**STAFF REPORT
KETCHUM PLANNING AND ZONING COMMISSION
SPECIAL MEETING OF AUGUST 13, 2019**

PROJECT: Sun Valley & 1st

FILE NUMBER: P19-083

REQUEST: Design Review of a remodel and addition to the existing building located at the corner of Sun Valley Road and 1st Avenue to accommodate 3 new retail areas, 2 community housing units, and 2 upper level condominium units

COPYRIGHT © 2019
DRAWING
FLOOR PLANS - PROPOSED
DWG. #

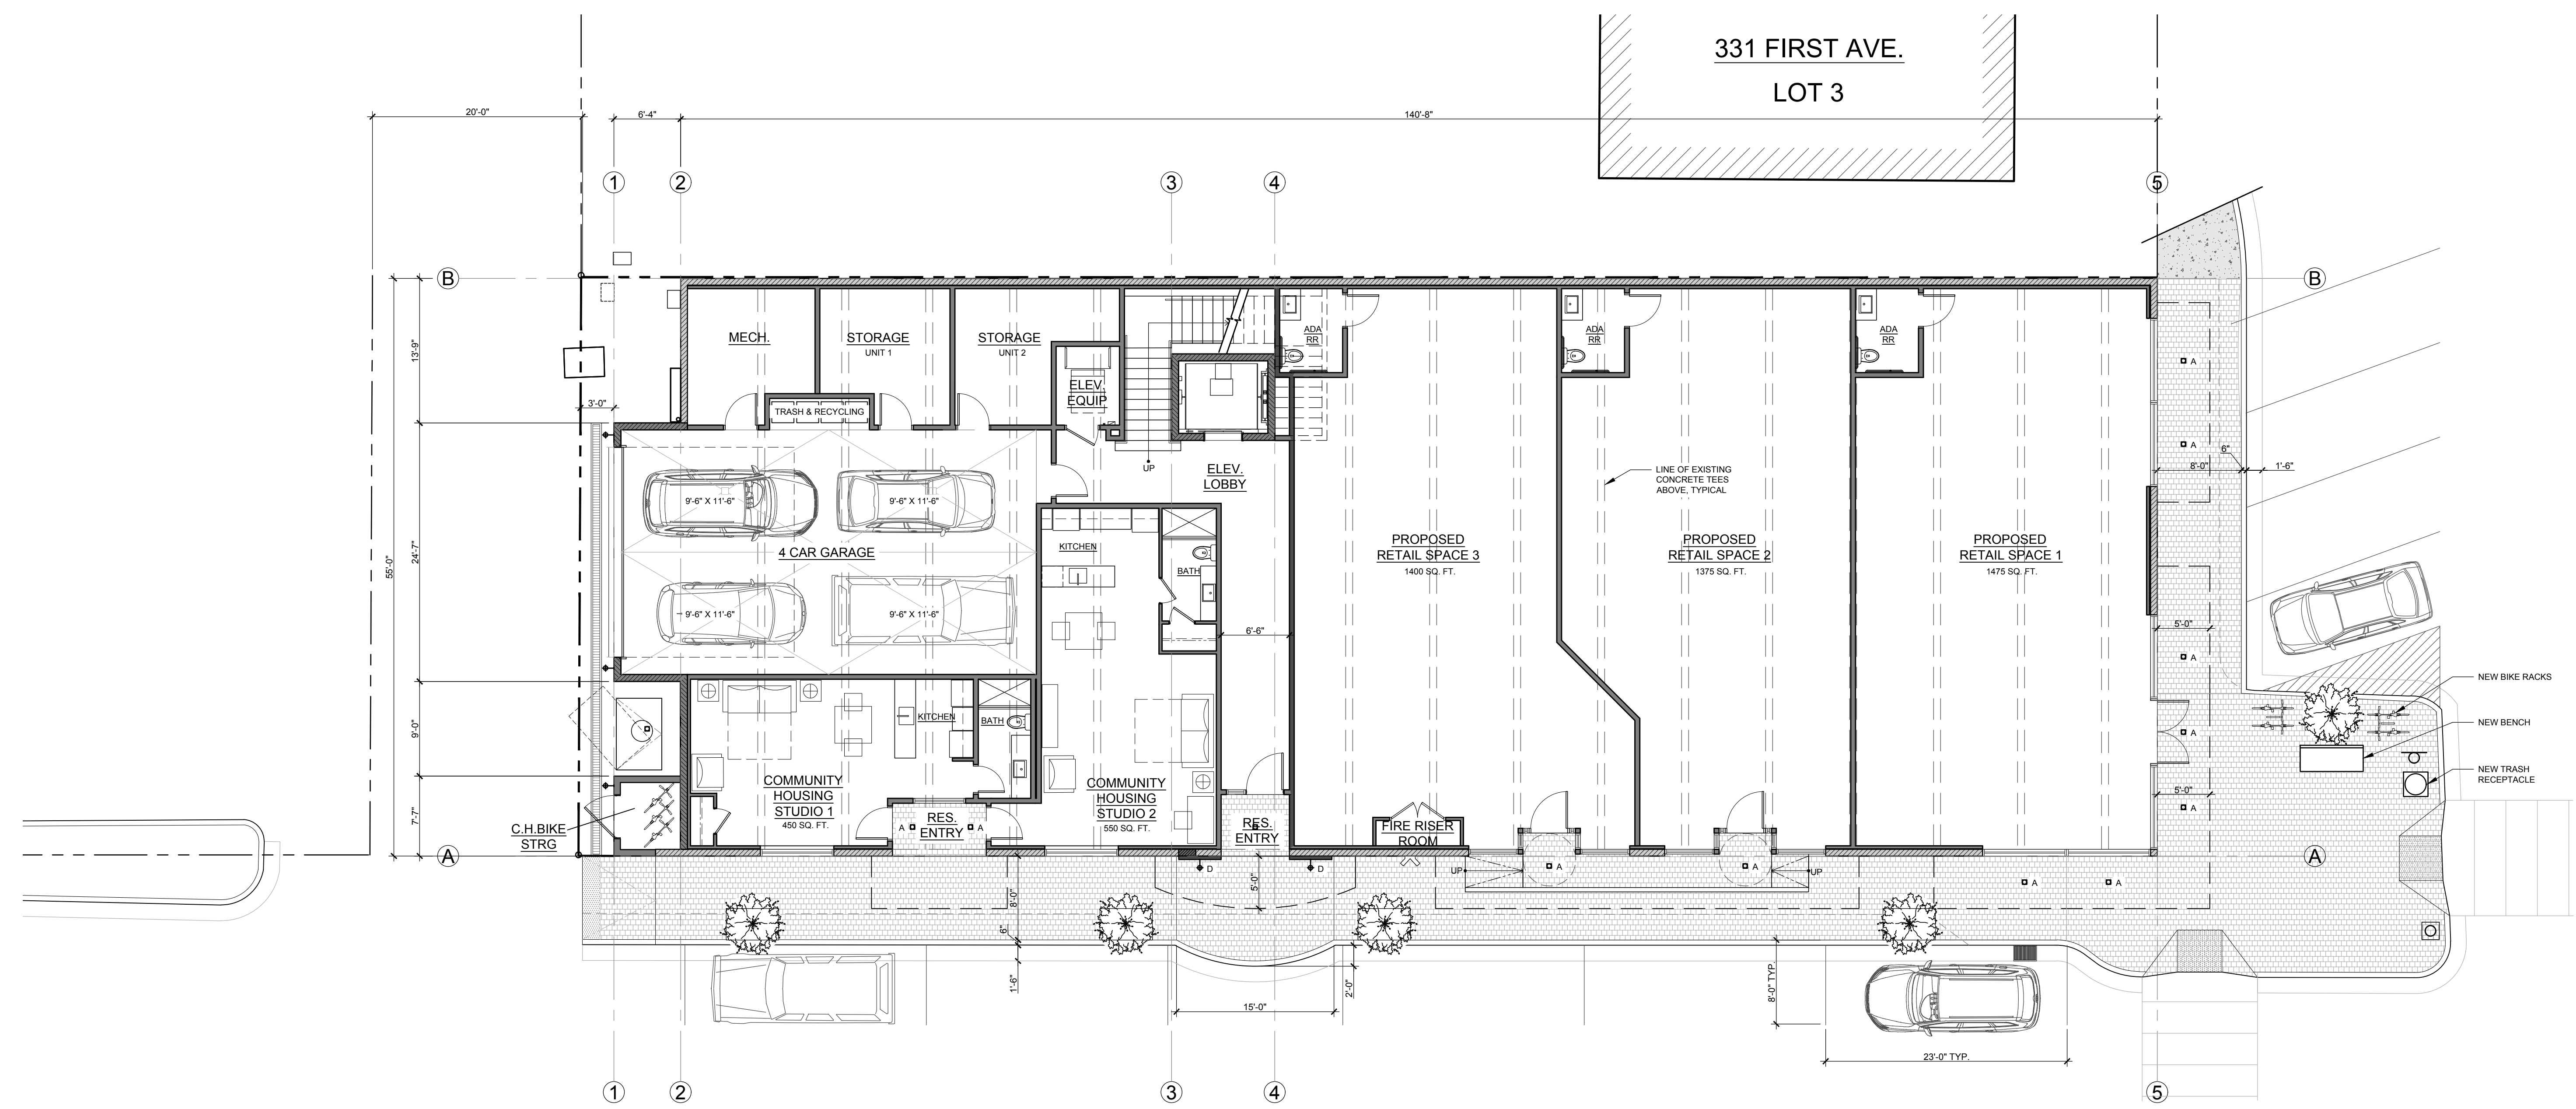
<i>Staff Comments</i>	<i>The landscape plan is included on Sheet A0.1. The applicant has proposed 5 street trees, which are specified as 3" caliper autumn blaze maples. All street trees will require electrical outlets and irrigation. The applicant has also proposed planters at the rooftop terrace.</i>
<input checked="" type="checkbox"/>	<input type="checkbox"/>	<input type="checkbox"/>	17.96.060(I)(2)	Landscape materials and vegetation types specified shall be readily adaptable to a site's microclimate, soil conditions, orientation and aspect, and shall serve to enhance and complement the neighborhood and townscape.
			<i>Staff Comments</i>	<i>The applicant shall specify the materials and vegetation for the rooftop planters with the Building Permit application. The landscape materials and vegetation types shall be reviewed and approved by the City Arborist prior to issuance of a Building Permit for the project. The landscape materials and vegetation types specified shall be readily adaptable to the site's microclimate, soil conditions, orientation and aspect, and shall serve to enhance and complement the neighborhood and townscape.</i>
